EPC STORMWATER REVIEW COMMENTS
IN ORANGE BOXES WITH BLACK TEXT

Preliminary Drainage Report

Overlook at Homestead Subdivision El Paso County, Colorado

PCD Filing No.: **SP238**

APEX RANCH ESTATES
FINAL DRAINAGE MAP
DEVELOPED CONDITIONS

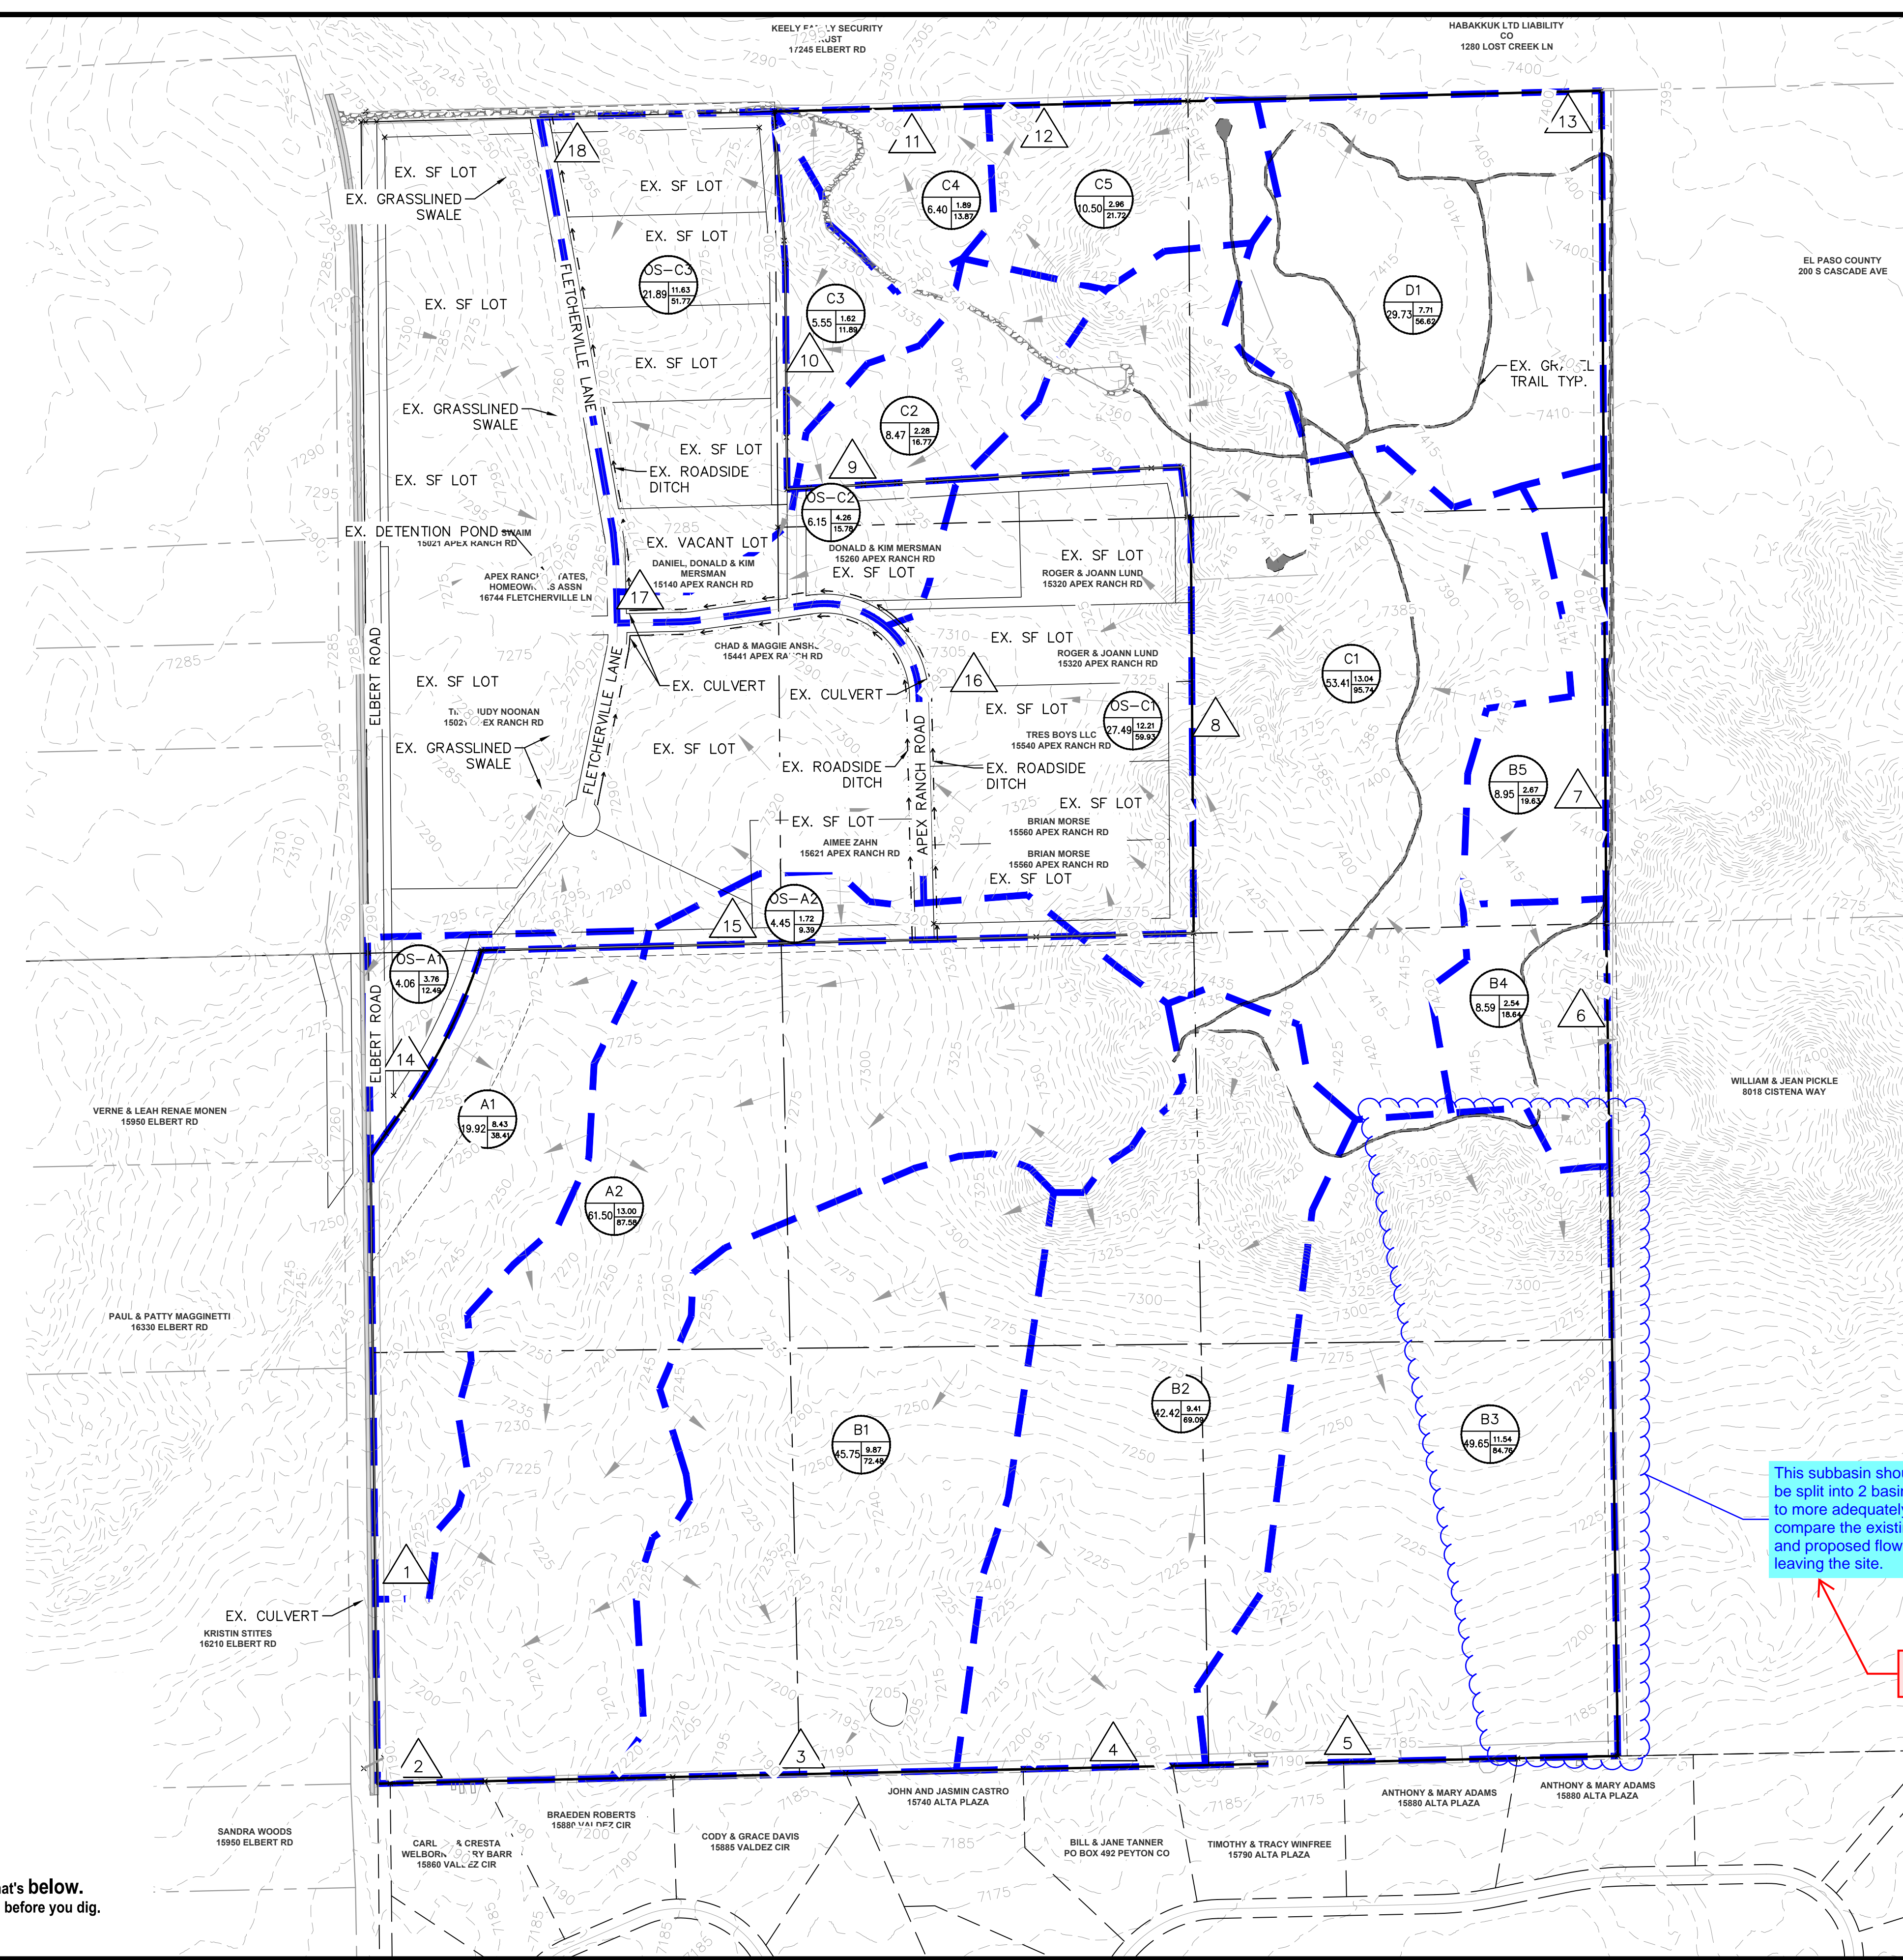
Provide excerpt of impervious values used for this basin

Impervious values are not provided in existing report. The only impervious values provided are those used in pond sizing.

OVERLOOK FILING NO. 1
EL PASO COUNTY, COLORADO
PRELIMINARY DESIGN PLANS
EXISTING DRAINAGE MAP

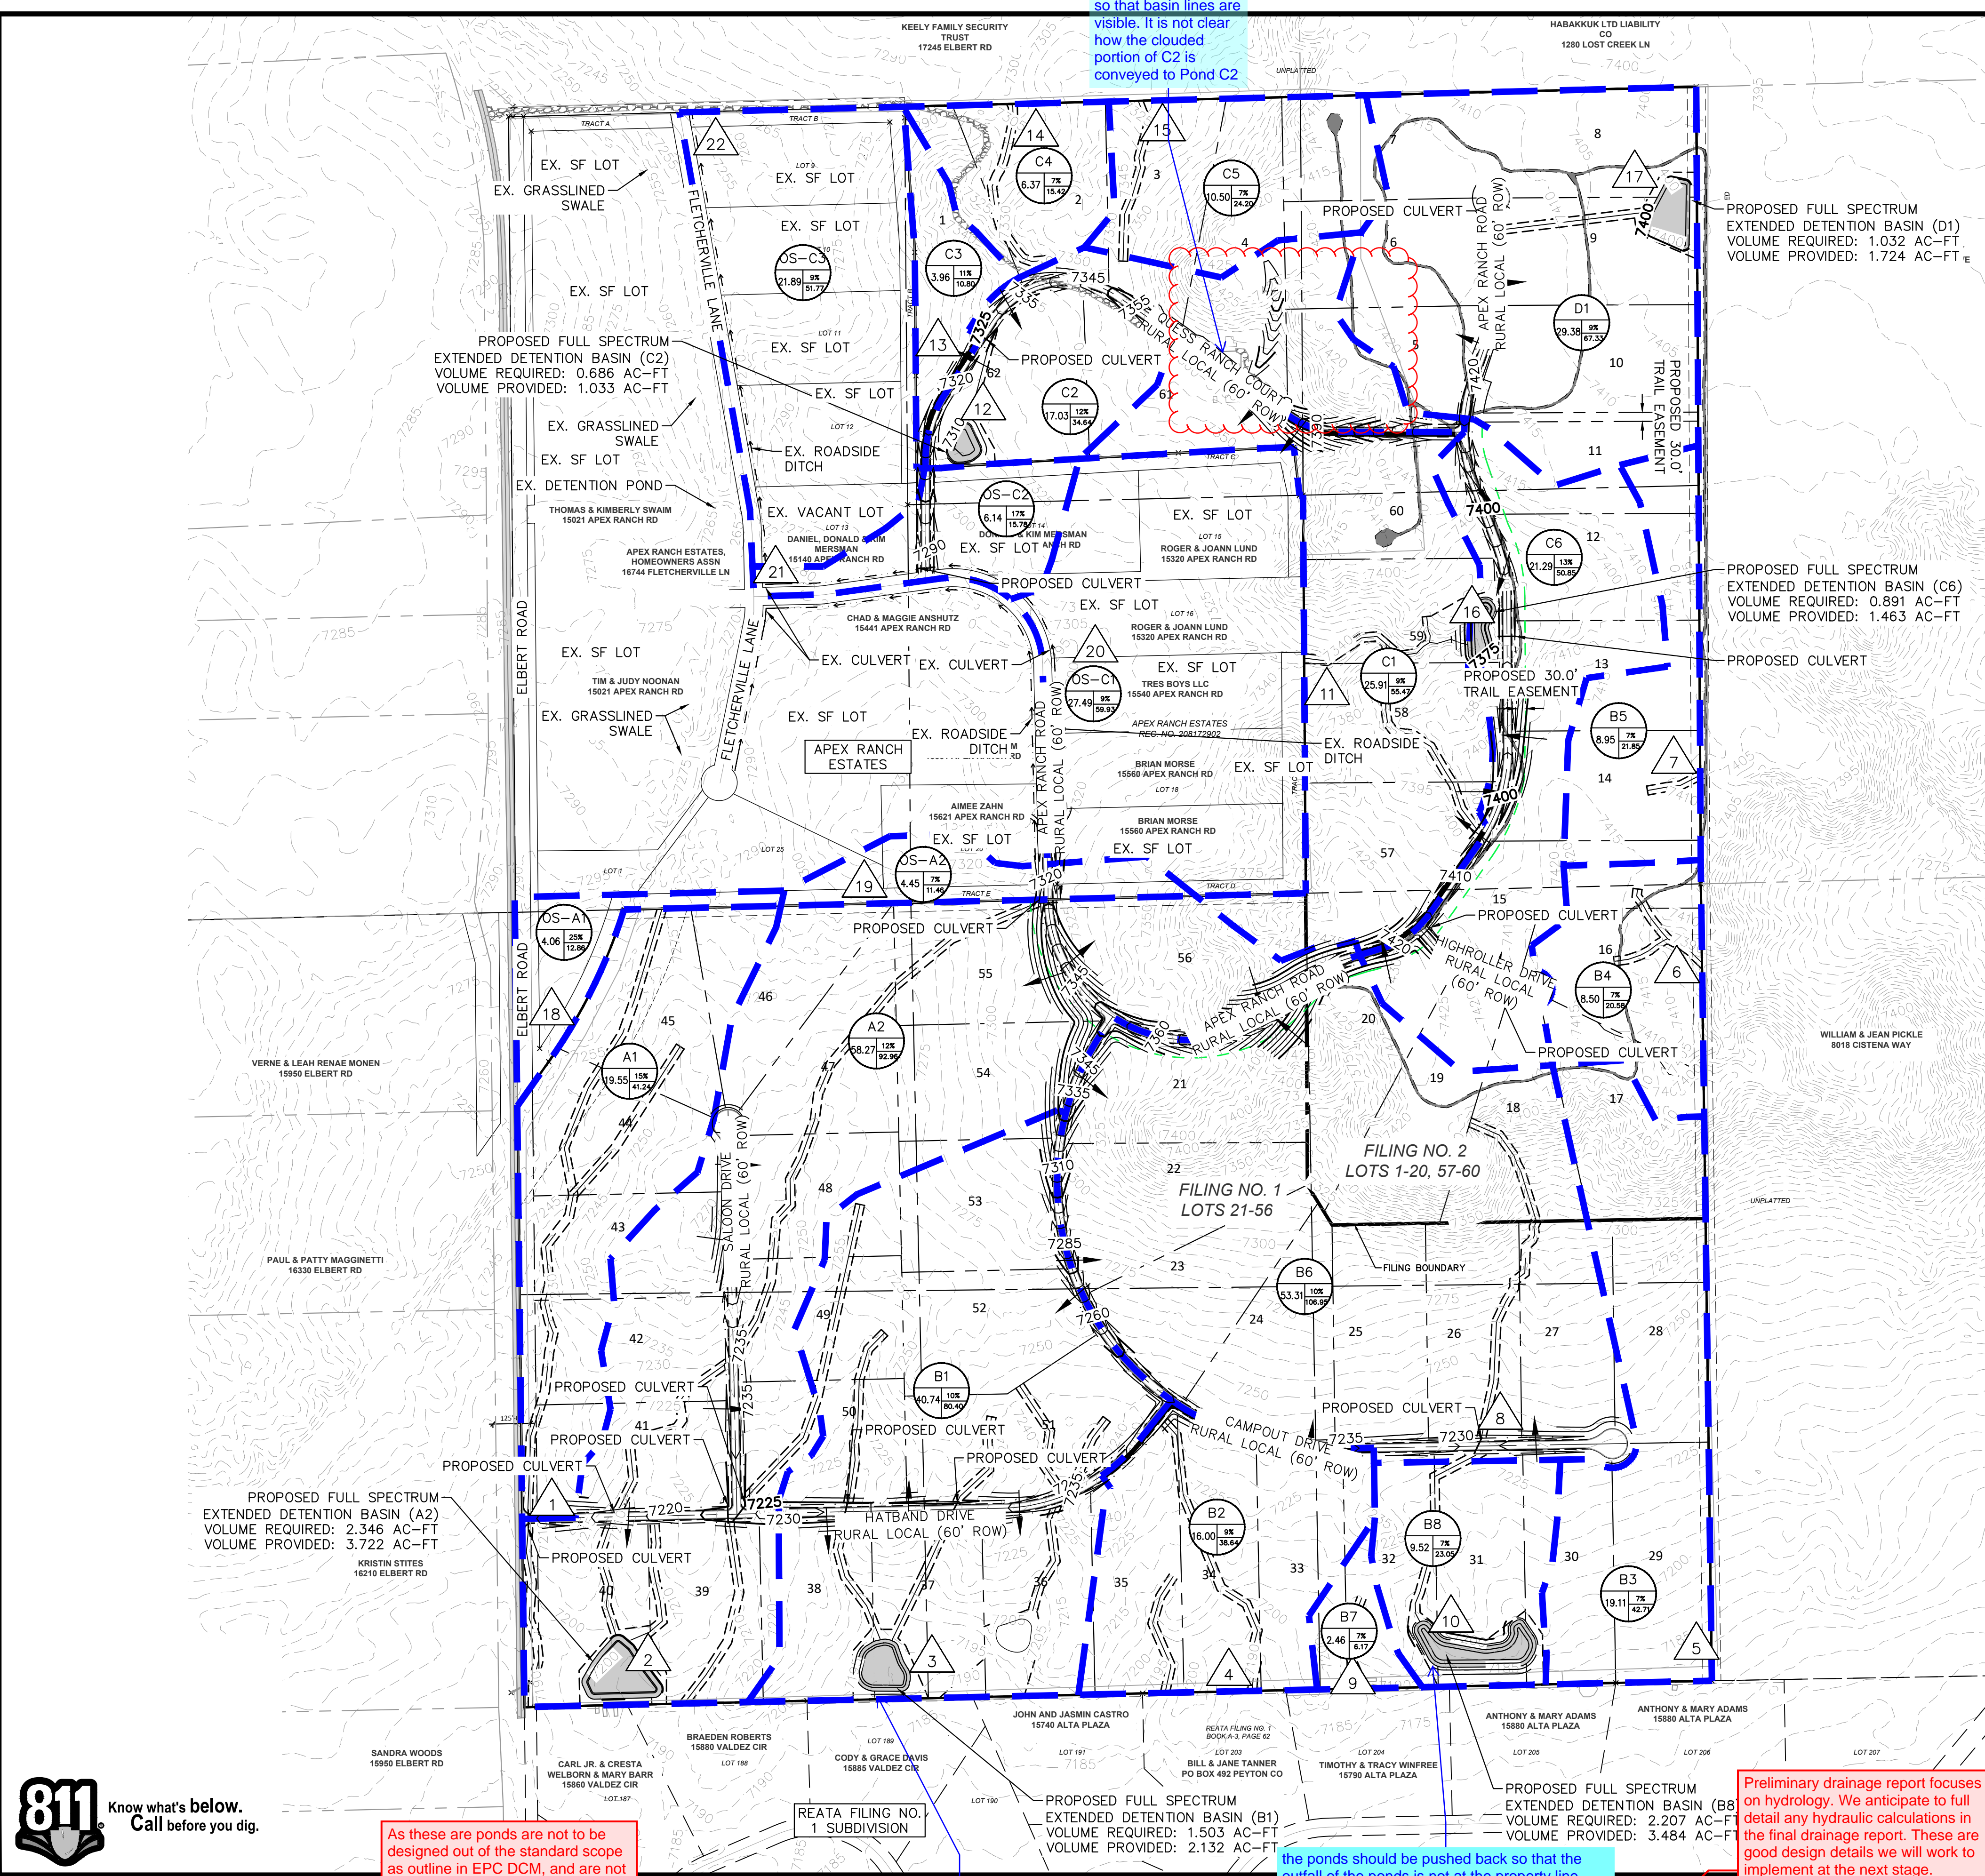
This subbasin should be split into 2 basins to more adequately compare the existing and proposed flows leaving the site.

Noted, sub-basin split to provide better clarity for comparison.

PRELIMINARY DESIGN PLANS
PROPOSED DRAINAGE MAP

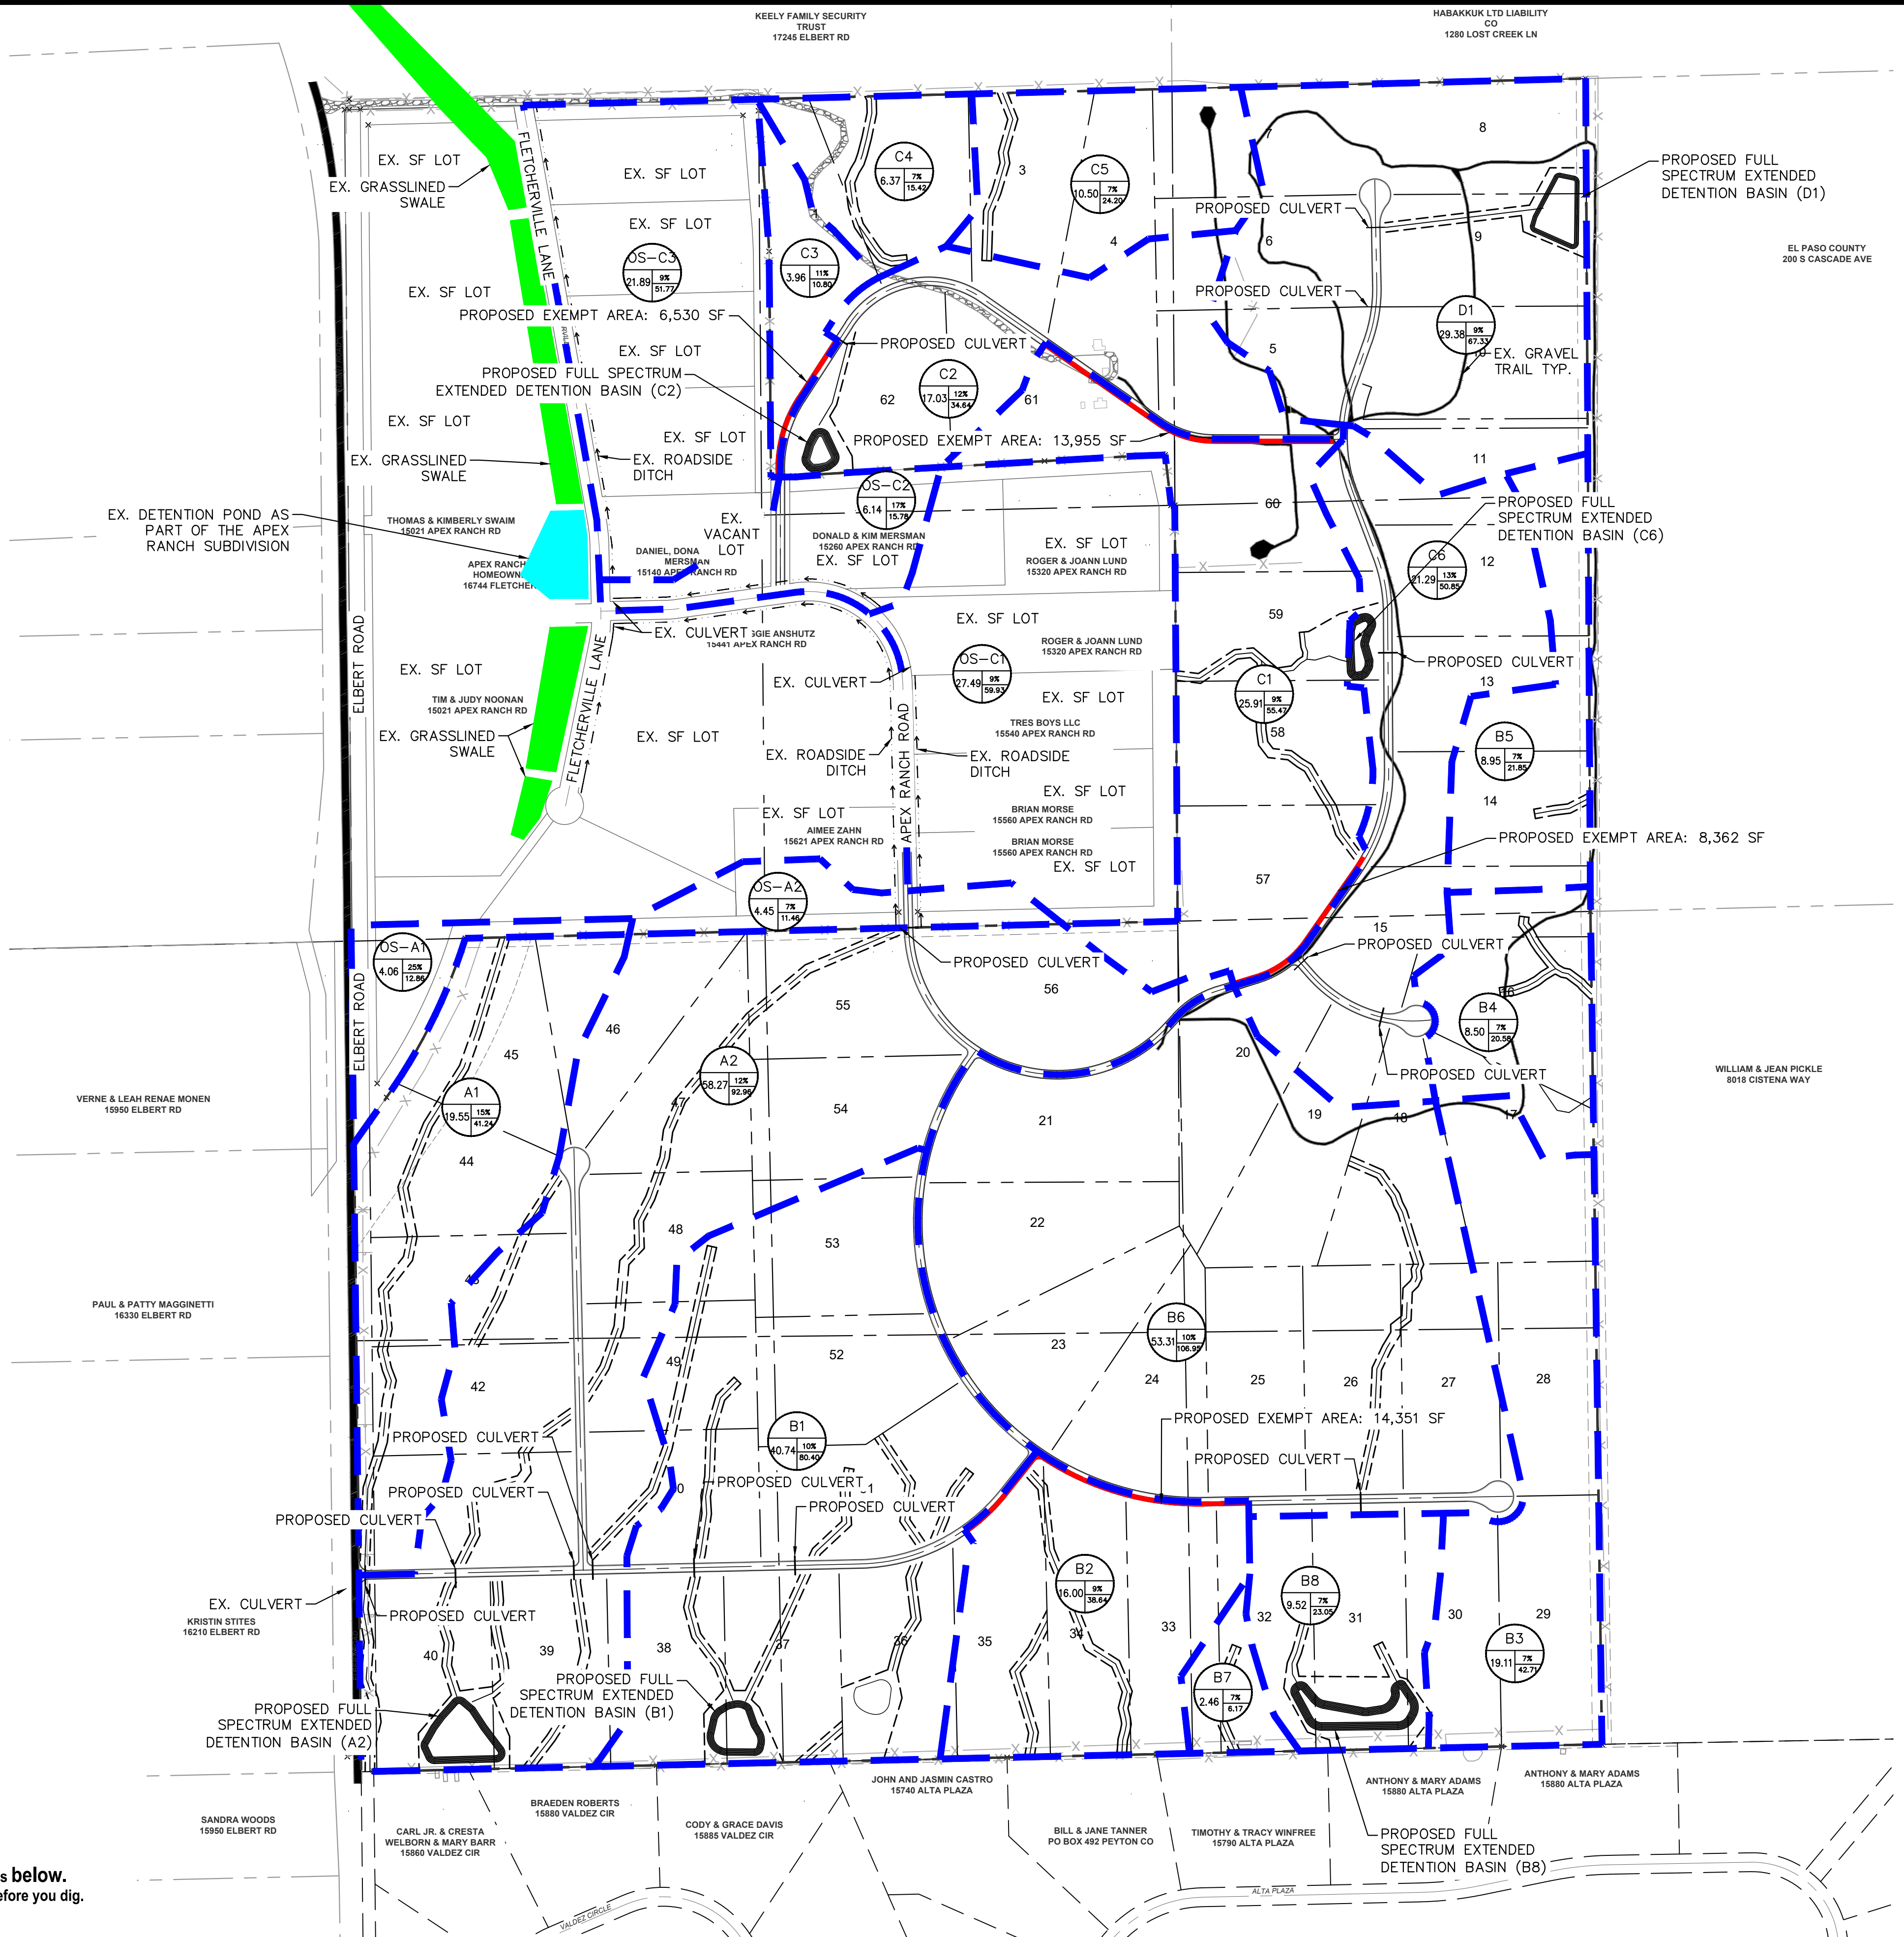
Please contact the state regarding the location of these ponds. A breach analysis may be required due to the proximity of the down stream residences.

As these are ponds are not to be designed out of the standard scope as outline in EPC DCM, and are not planned on being state jurisdictional dams, thus we anticipate that state breach analysis should not be required. Preliminary drainage report focuses on hydrology. We anticipate to full detail any hydraulic calculations in the final drainage report.

Preliminary drainage report focuses on hydrology. We anticipate to full detail any hydraulic calculations in the final drainage report. These are good design details we will work to implement at the next stage. Specific pond location and outfall location are to be designed in detail in final drainage report. Ponds release rates are to be designed less than historic conditions.
